Q-22-737

ADDENDUM NO. 2

REQUEST FOR QUOTATION

FORT RITCHIE MANHOLE MONITORING

STANDARD NO. MD 578.01

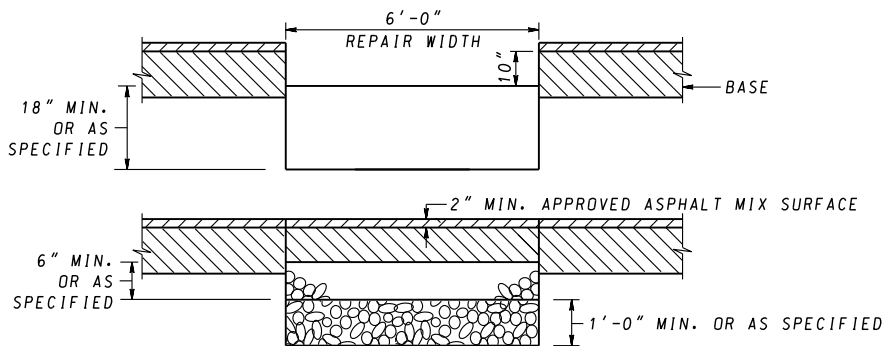
ITEM NO. 5: Inquiry: Please confirm the “boring” limits on the project profile provided. Considering the fact that all existing utilities must be verified before boring can occur, there will be multiple asphalt cuts in the roadway to perform any boring activities. It may be beneficial to consider an open cut crossing of the roadway in lieu of boring. Will both boring and open cut crossings of the roadway be permitted for this project?

ITEM NO. 6: Inquiry: There is a patching/restoration detail provide for “County” roadways but not for State Highway. Please identify the “County” and “State Highway” limits on the project profile provided. Additionally, please provide the appropriate State Highway patching detail applicable to this project.

Response: Yes, an application to open cut the crossing has been submitted to MDOT in the event the contractor elects to pursue this option. Please be advised that if the open cut option is pursued, the pavement restoration shall be completed this year. Please find the MDOT pavement repair detail attached to this Addendum.

Response: Part 1 of Item No. 6 herein: The roadway crossing is entirely within the limits of Maryland State Highway.

Response: Part 2 of Item No. 6 herein: Please find the MDOT pavement repair detail attached to this Addendum.
